**AMERICAN TRANSMISSION SYSTEMS, INCORPORATED  
A SUBSIDIARY OF FIRSTENERGY CORP.**

**AMENDMENT TO EAST SPRINGFIELD-LONDON-  
TANGY 138 kV TRANSMISSION LINE**

**OPSB CASE NO.: 13-2112-EL-BTA**

**October 29, 2013**

FIGURE 04-1L  
REVISION 1  
CONSTRAINTS MAP FOR  
THE LONDON-TANGY SEGMENT

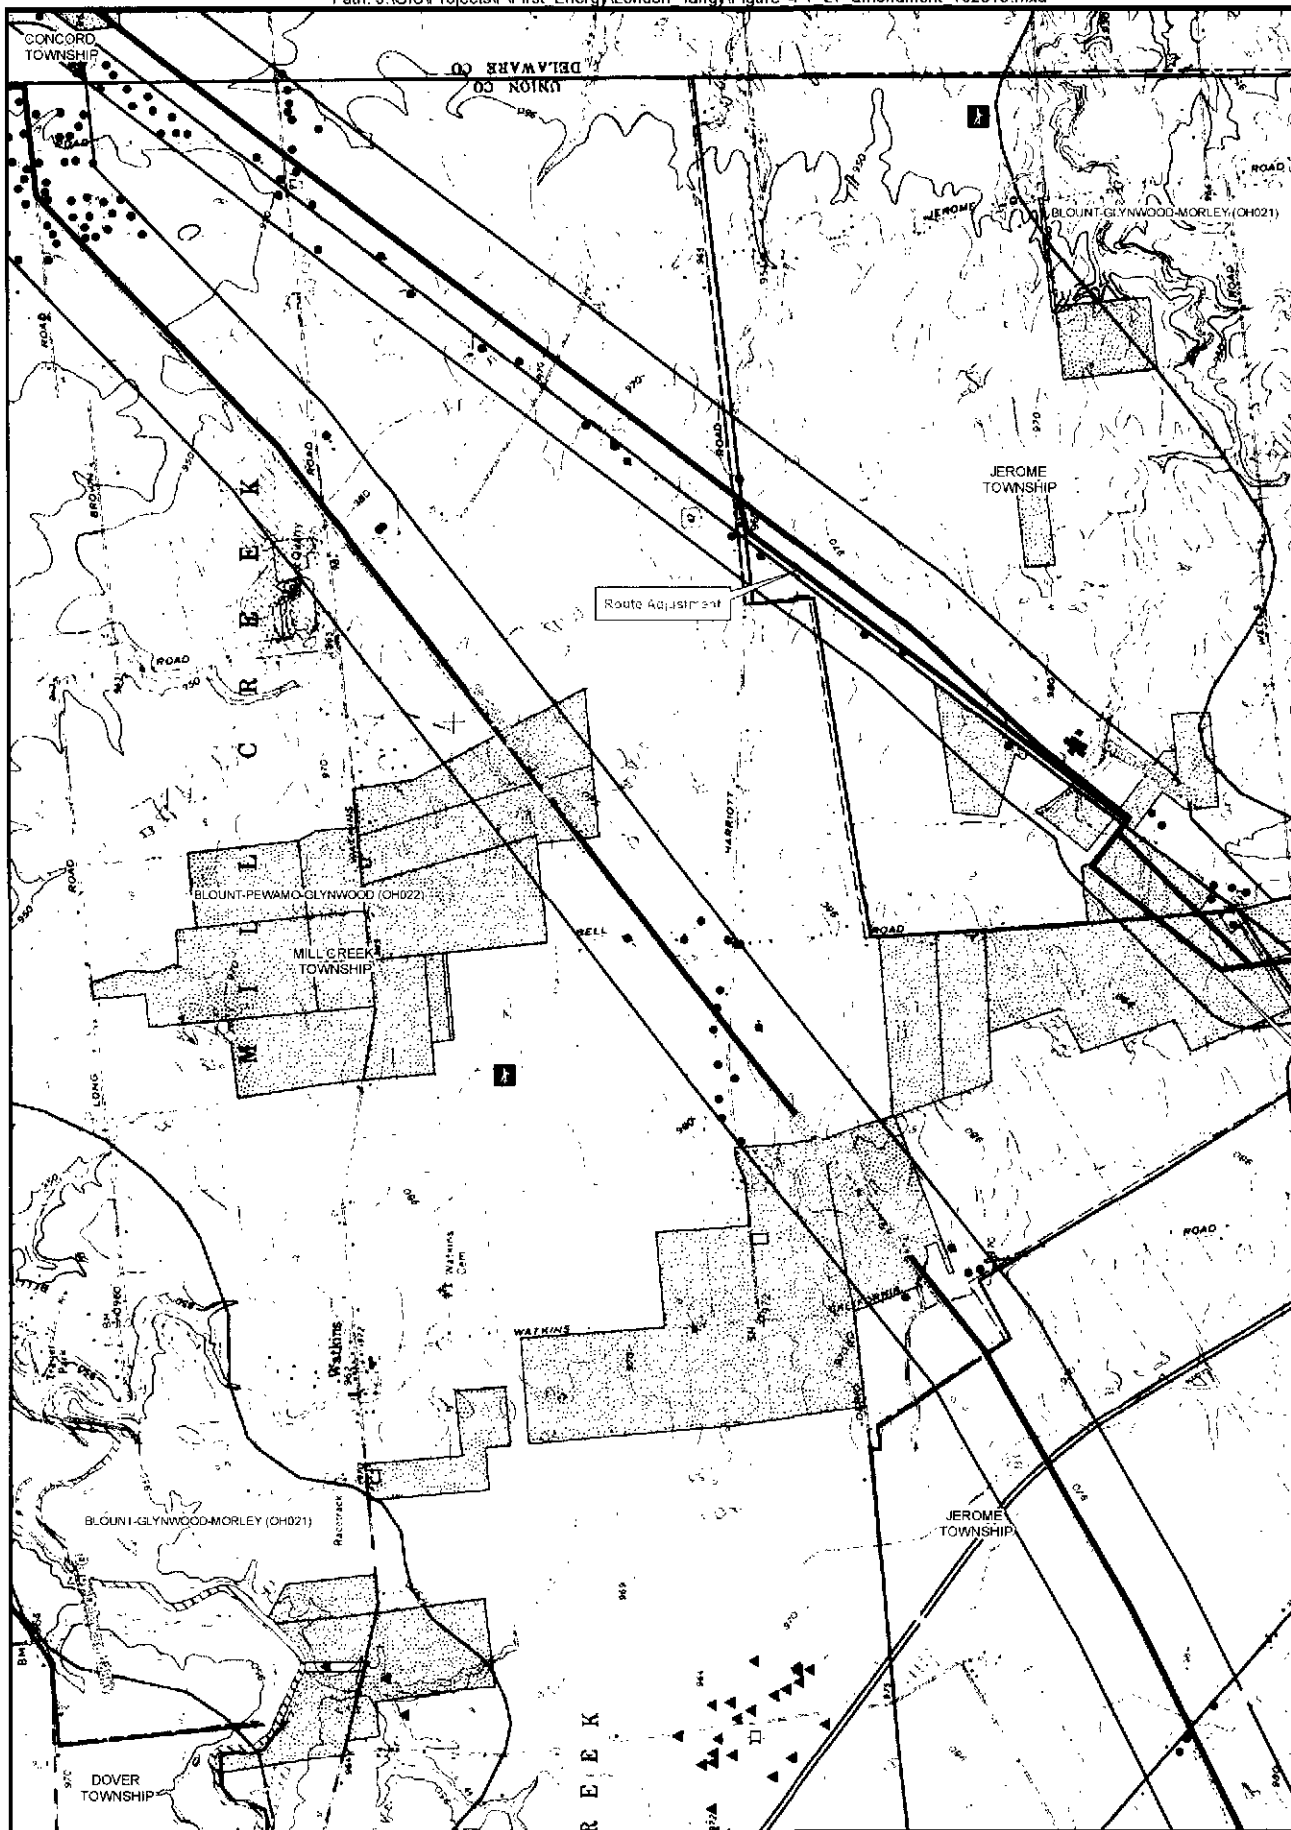
As shown in Figure 04-1L Revision 1, after the southeasterly trending crossing of U.S. Highway 42 North, the Approved Route continues southeast for approximately 120 feet, where it then turns approximately 90 degrees to the north-northeast and traverses approximately 0.3 mile where it then turns slightly five degrees to the northeast and continues for approximately 0.5-mile. At this point the Approved Route turns 10 degrees north-northeast and continues approximately 0.7-mile toward Harriott Road. The proposed adjustment of the Approved Route in this area begins approximately 75-feet to the southeast of the U.S. Highway 42 North. At this point, the adjusted route of the transmission line will turn approximately 90 degrees to the north-northeast and parallel U.S. Highway 42 North for approximately 1.4-miles northeasterly, where it then turns 40 degrees to the northeast. The adjusted route continues northeast for approximately 500 feet and turns approximately 40 degree north-northeast to rejoin the Approved Route.

The property owners along this section of the Project have requested the change of the Approved Route. The Applicant has no objection to the change of the Approved Route requested by the property owners and believes the change does not significantly increase or decrease ecological impacts. On the Select Sires Inc. properties (1400090080010, and 1400090150000), the proposed adjustment moves the Approved Route further northwest in closer proximity to U.S. Highway 42 North near an existing distribution line, which will be relocated onto the new

FIGURE 04-1M  
REVISION 1  
CONSTRAINTS MAP FOR  
THE LONDON-TANGY SEGMENT

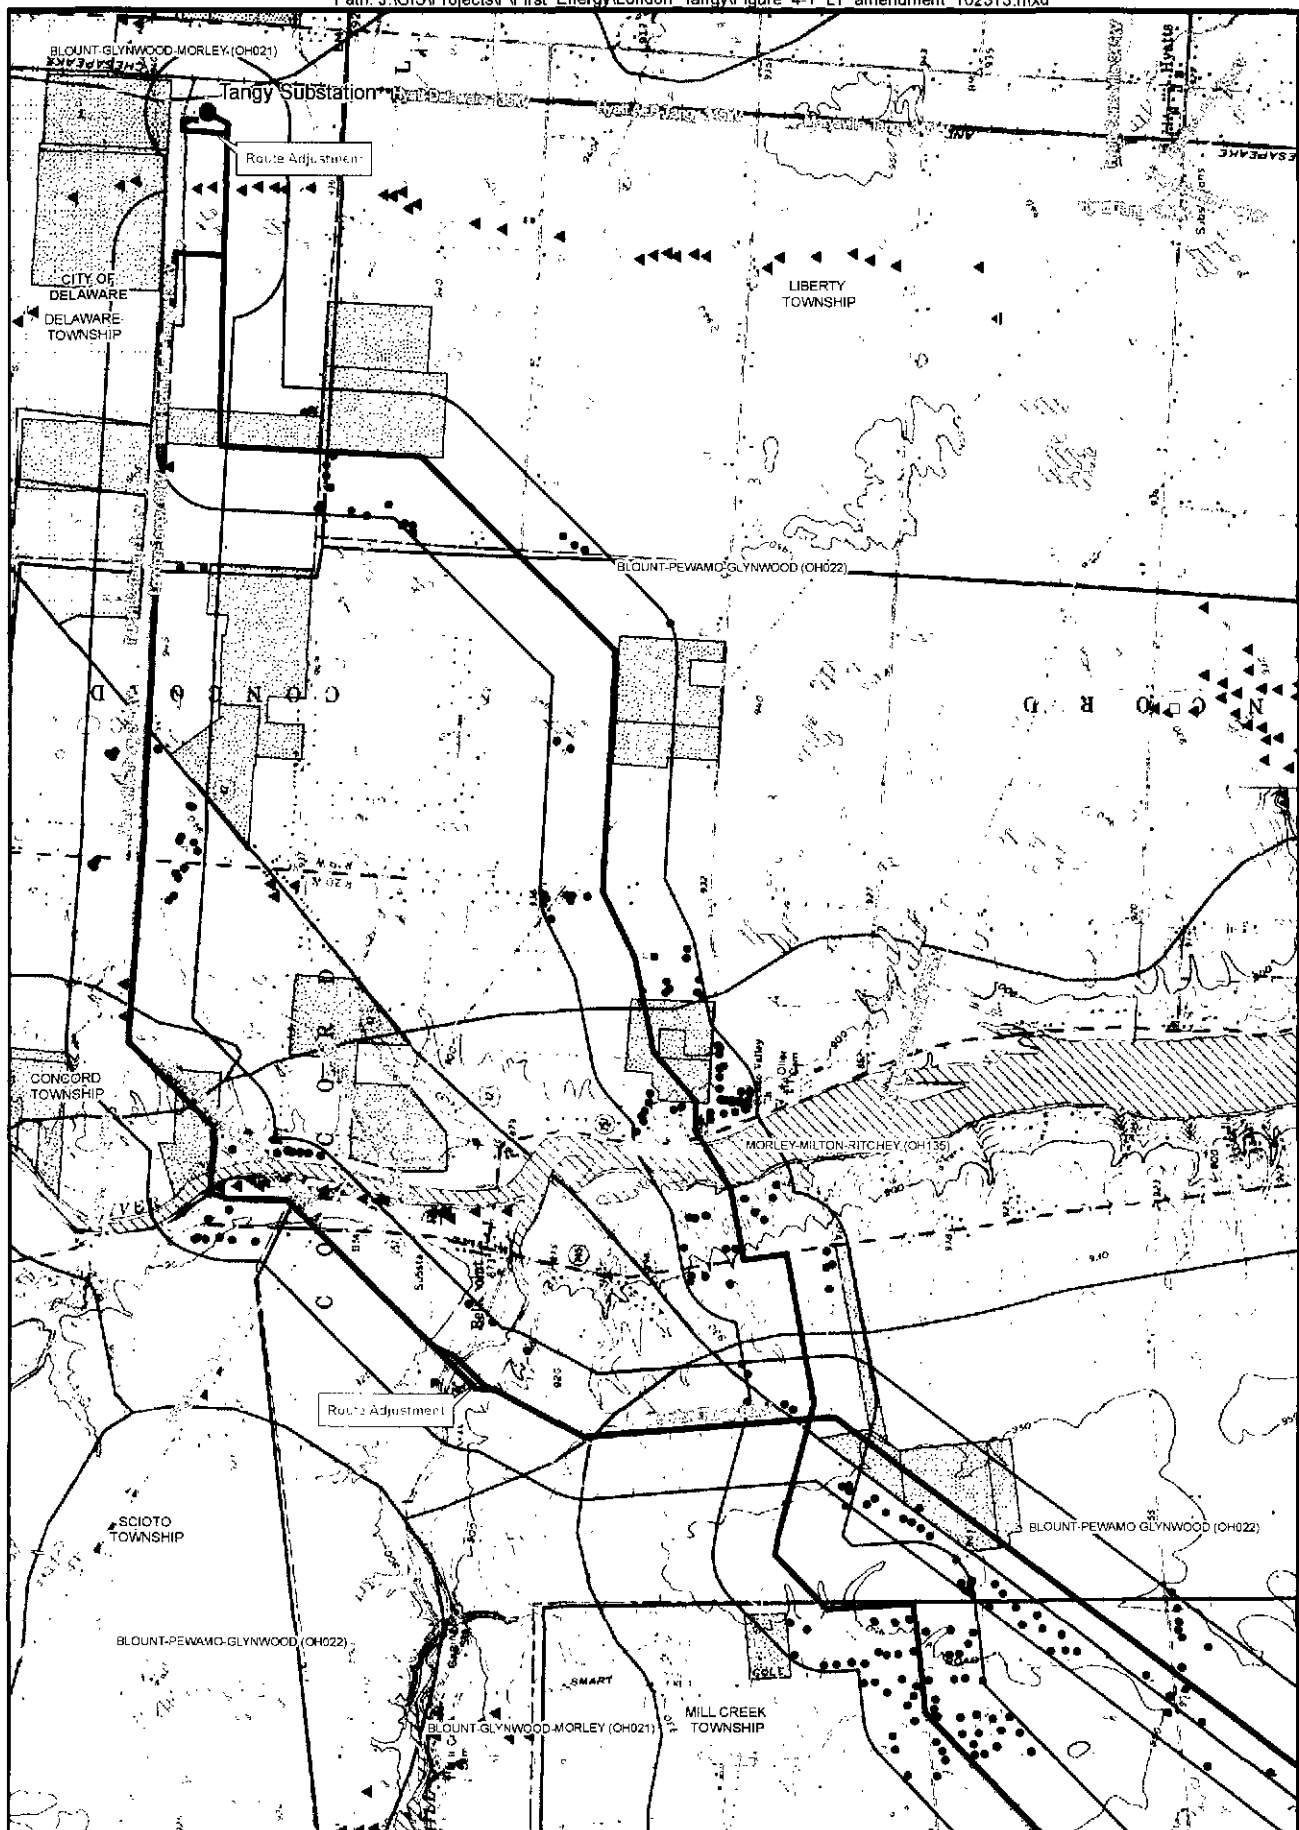
As shown in Figure 04-1M Revision 1, at approximately 680-feet to the south of Mills Road the Approved Route traverses in a northeasterly trending direction before turning approximately 25 degrees to the north. At this point, the Approved Route continues 350-feet north where it turns approximately 45 degrees northeast and continues trending northeast across Mill Creek and Mills Road. The proposed adjustment of the Approved Route in this area begins approximately 0.15-mile to the south of Mills Road. At this point, the adjusted route of the transmission line will turn approximately five degrees north and continue approximately 150-feet to the north where it then turns approximately 20 degrees to the north-northeast. The adjusted route continues approximately 700-feet north-northeast before turning approximately 25 degrees to the north and traverses generally north for approximately 400-feet where it rejoins the Approved Route.

The proposed adjustment is requested by the Applicant and is beneficial as it avoids potential clearing impacts to two high quality Category 3 wetlands that were identified during environmental surveys onsite. The proposed adjustment avoids the clearing impact to Wetland Pr-w015 and Wetland Pr-w017 by moving the transmission line on the same property and by placing the alignment approximately 140-feet to the northeast of the Approved Route. The adjusted route decreases ecological impacts as it will only cross one wetland in this area (Wetland Pr-w016) and it was classified as a slightly lower quality Category 2 wetland. This adjustment represents a minor change to the Approved Route and the proposed adjustment is entirely within properties originally crossed by the Approved Route. Although the property owners did not specifically request this adjustment, the owners of these parcels are in agreement with the proposed alignment and the remaining portion of the Approved Route on the properties.

As shown in Figure 04-1M Revision 1, the Approved Route trends in an easterly direction as it enters the west side of the Tangy Substation. The change to the Approved Route begins on the section of the route that is approximately 150-feet from the western edge of the Tangy Substation. At this point, the adjusted route begins by turning 90 degree to the north and traverses approximately 750-feet north before turning 90 degrees to the east. The adjustment continues east for approximately 175-feet and then turns 90 degrees to the south and enters the Tangy Substation.

The proposed adjustment is requested by the Applicant based on the need for the transmission line to enter from the substation from the north due to substation engineering design. This adjustment represents a minor change to the Approved Route and is entirely located on the Applicant property. The Applicant believes the change does not significantly increase or decrease ecological impacts or impacts to neighboring property owners.
